Planning application no. LCC/2014/0101

by Cuadrilla Bowland Limited to drill at

Roseacre Wood, Lancashire:

Objection on grounds of geology and hydrogeology

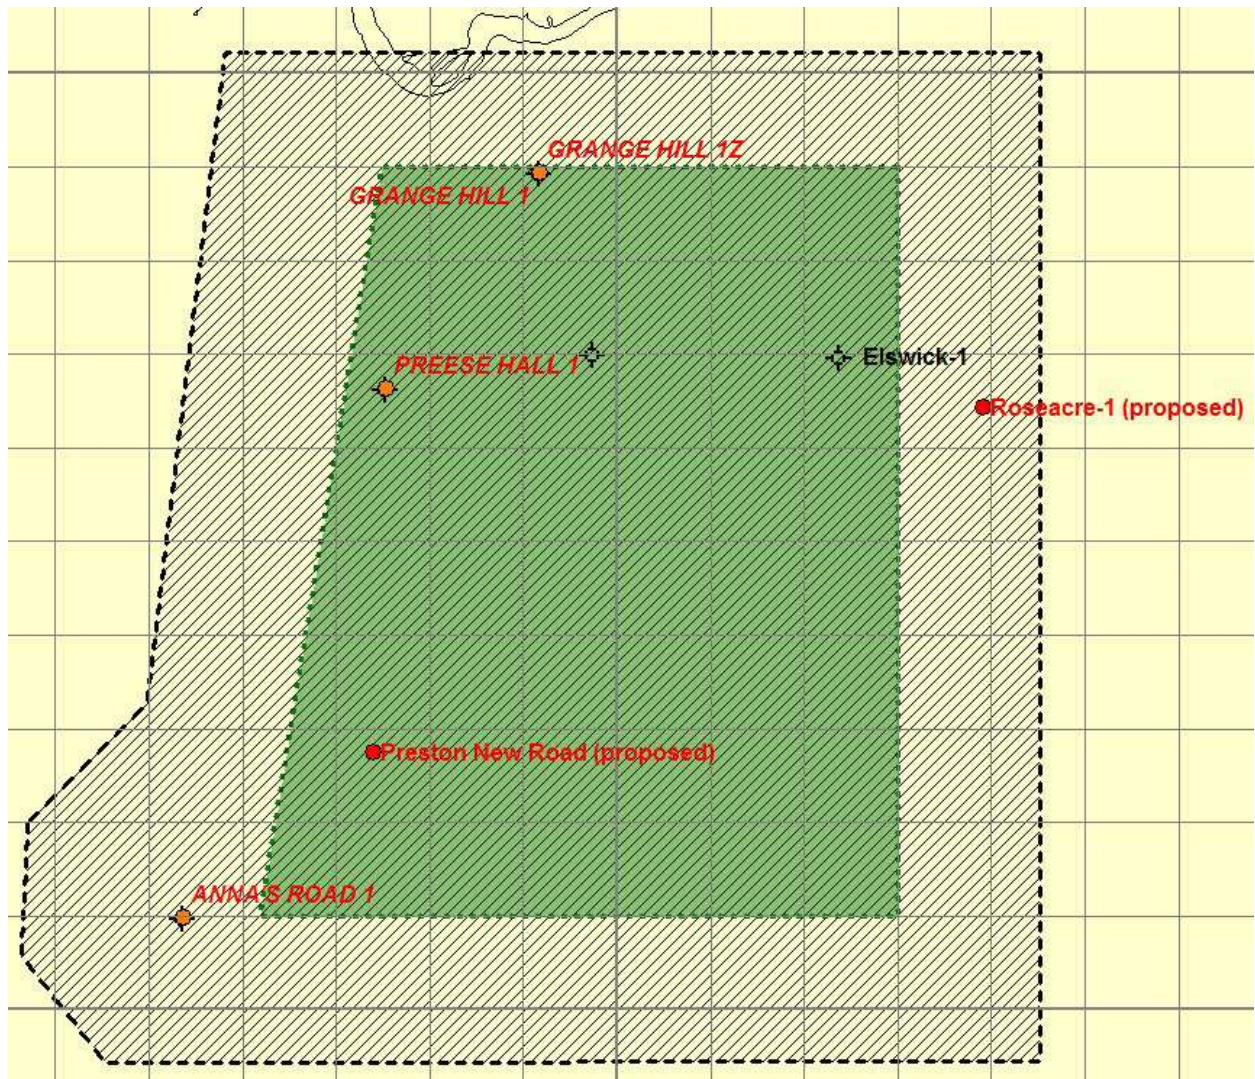
Figure 2.1 shows the surface extent of the sources and receivers used in the 3D survey (diagonal hatching). But only within the area coloured green is the survey at its full fold, and therefore capable (in principle) of imaging all the structure below. Outside of this area, the data quality diminishes progressively from a possible 60-fold at the edge of the green area to 1-fold at the edge. So the 3D image below the proposed drillsite will be of poor quality.

In order to clarify these deficiencies the applicant should supply for the seismic dataset and its interpretation:

1. The acquisition and the processing reports.
2. Numerous examples of seismic cross-sections through the 3D volume, in triplets comprising raw pre-stacked time, raw depth-converted and depth-converted with superimposed interpretation; around five E-W images and five N-S images should suffice, passing through existing wells.

3. These cross-sections should be accompanied by a graph above or below showing the fold (multiplicity) of coverage, as an indication of data quality.
4. Examples of well-tie to seismic *via* velocity and/or VSP logs should be shown, both for wells within the 3D area and, using 2D seismic, for other wells within the licence area.
5. The 'independent' interpretation review report carried out by Arup/DMT.

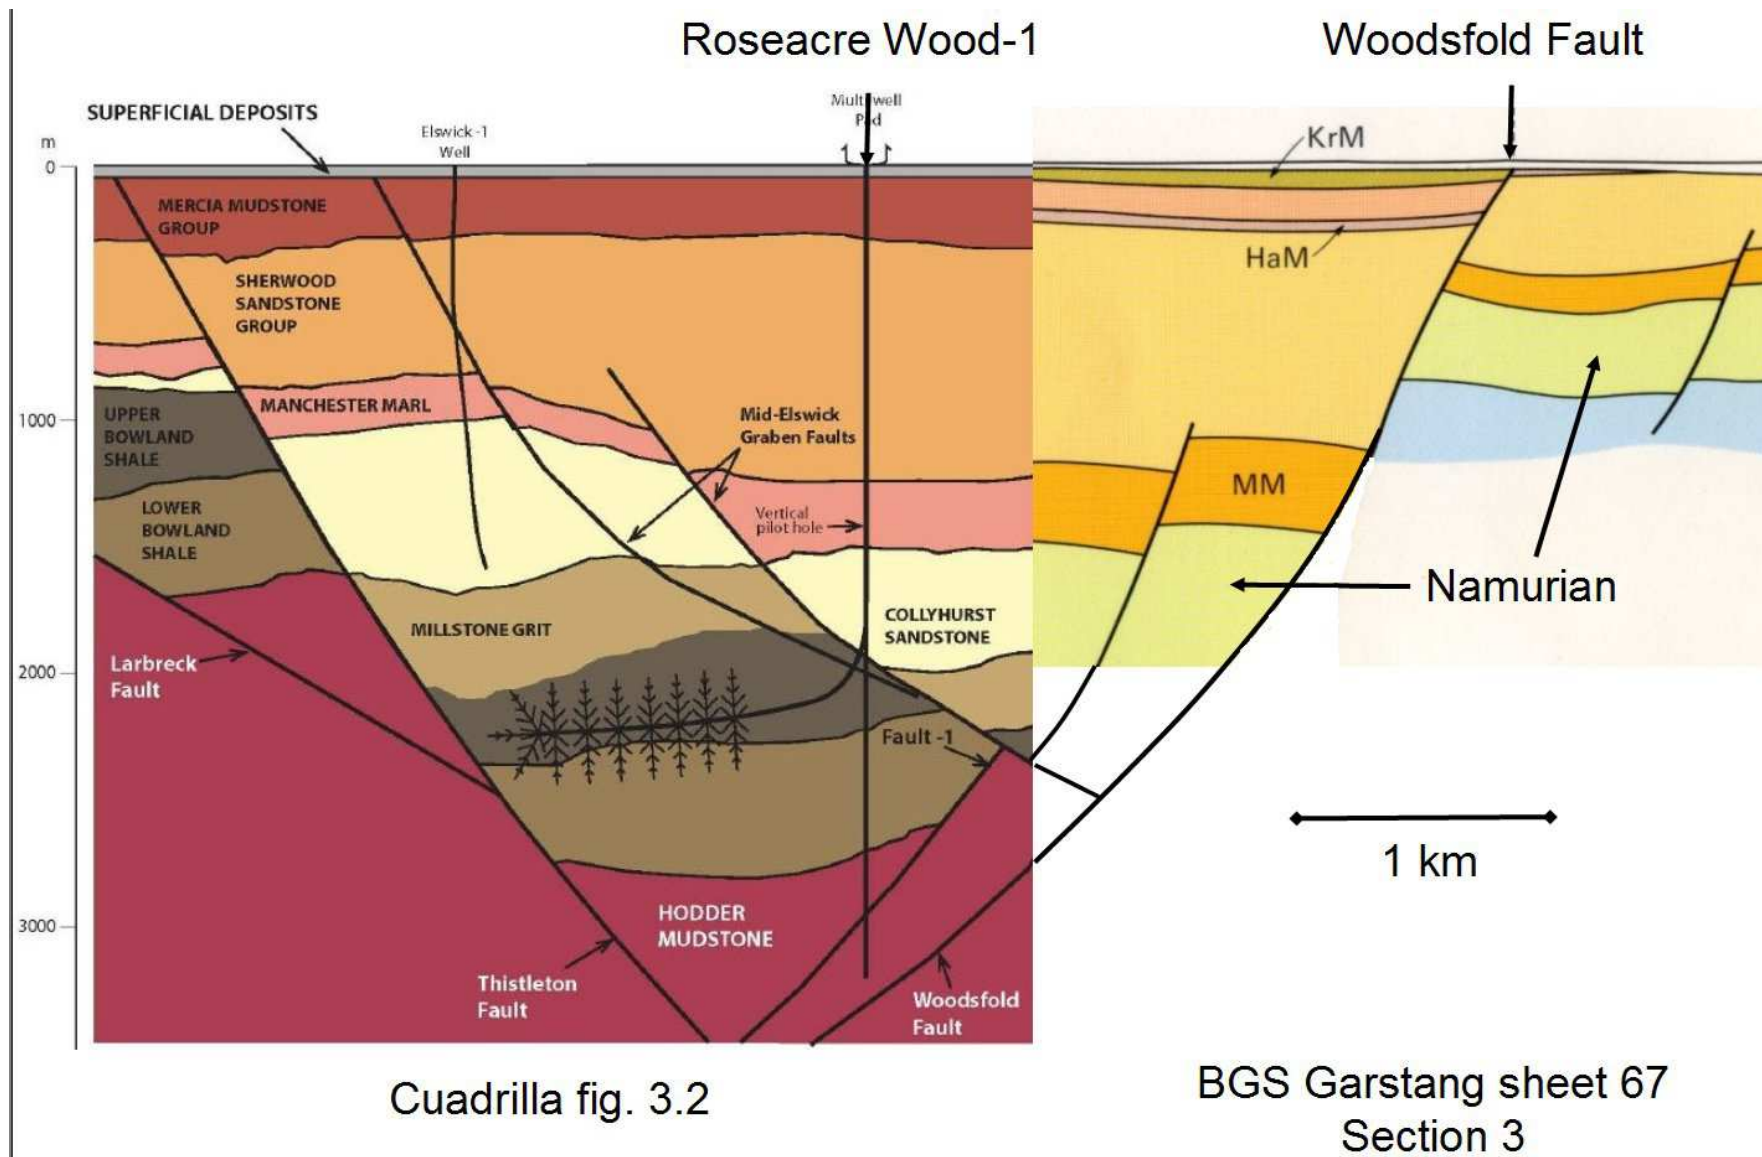
Fig. 3.2 shows the Cuadrilla cross-section through the proposed well (ES vol. 1 p. 23, fig. 3.2) combined with cross-section 3 from BGS Garstang sheet 67. The former is 3.6 km long, and there is a gap of 300 m between the right-hand end of this section and the nearest point of the BGS section. The BGS section, dating from 1990, is out of date in places. On the BGS section the Mercia Mudstone Group is subdivided into three layers, and is shown as slightly thinner than on the Cuadrilla version. There is a good match of the Manchester Marls (MM), but the BGS section shows Namurian (Upper Carboniferous) immediately below, with no Permian Collyhurst Sandstone. This error is because the BGS section was compiled before the existence of the Elswick-1 well which proved at least 500 m of Collyhurst Sandstone, as seen on the Cuadrilla side of the combined diagram. Presumably the Collyhurst Sandstone runs east to the Woodsfold Fault, where it is upfaulted to the east; the 'Namurian' (light green) labelling of the BGS part of the combined cross-section should be disregarded.

I have interpolated the Woodsfold Fault between the two cross-sections, and have continued the 'Mid Elswick Graben' faults as one single fault going deeper to the east to terminate against the Woodsfold Fault. All the faults appear to be post-early Sherwood Sandstone in age,

and the bigger ones are post-Mercia Mudstone Group in age. Cuadrilla's interpretation implies that the Thistleton Fault was a growth fault active during Collyhurst Sandstone deposition, to account for the vastly greater thickness of this rock group on the downthrown side. On the other hand, the more easterly of the 'Mid Elswick Graben' faults seems to be post-Collyhurst in age, but acted as a growth fault during Manchester Marls time.

The cross-section looks like it could not be 'balanced'. This means that it has internal inconsistencies, such as thicknesses of rock groups varying or disappearing without reasonable explanation. Only the westernmost two-thirds of the Cuadrilla segment of the cross-section, starting from about half-way between the Elswick-1 well and the proposed Roseacre well, is within the 3D 'full-fold' zone, as described in section 2.2 above. This casts further doubt on the reliability of the geological interpretation.

Doubts such as this about the validity of Cuadrilla's mapping, even when 3D seismic data has been used, make it crucial that examples of the 3D seismic data and its interpretation be provided for independent scrutiny.

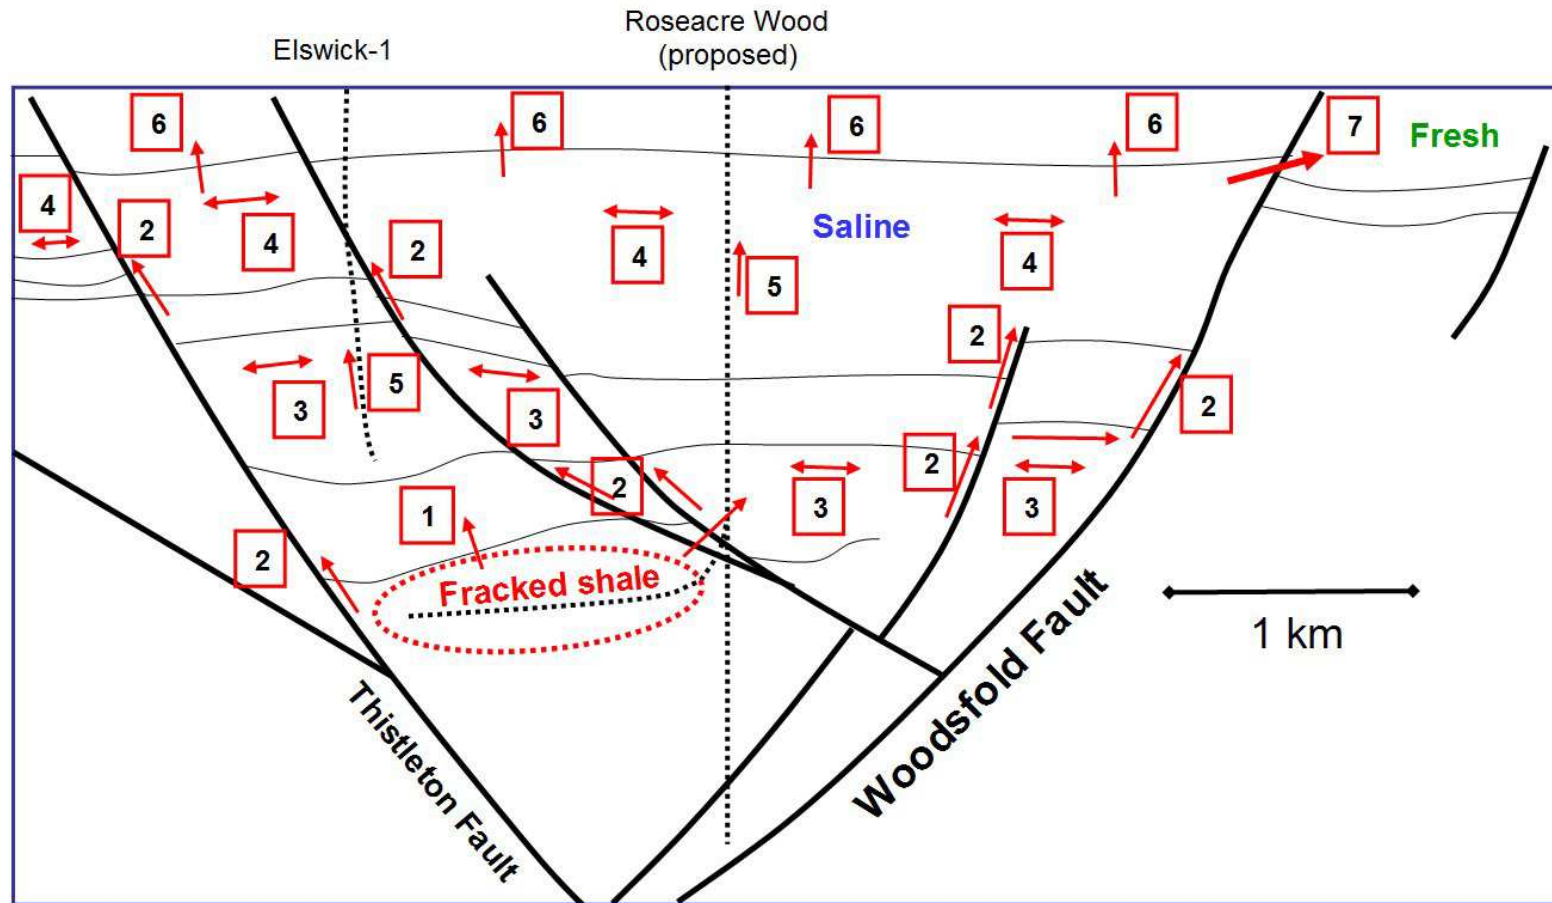
Figure 5.2 shows a line-drawing outline of the combined Cuadrilla/BGS geological cross-section through the proposed well, from Figure 3.2. Well tracks are shown as dotted lines. Faults are shown as bold solid lines, and geological boundaries as light solid lines. Numbers in red rectangles beside each arrow refer to likely fluid flow paths (with double-headed arrows indicating vigorous flow possible within a highly permeable layer):

More crucially, the Manchester Marls are only 270 m thick at the well (ES vol. 1, table 11.6, p. 298), and about half that thickness further west. This layer will not, therefore, provide a viable cap-rock. In any case, flow paths 1 and 2 (Fig. 5.2) permit rapid migration along the highly permeable Collyhurst Sandstone below. The drillsite pad is only 2.6 km from the outcrop of the Woodsfold Fault, which, I have argued, will be transmissive. Below ground **the drill hole is only about 1500 m horizontally away from the fault.**
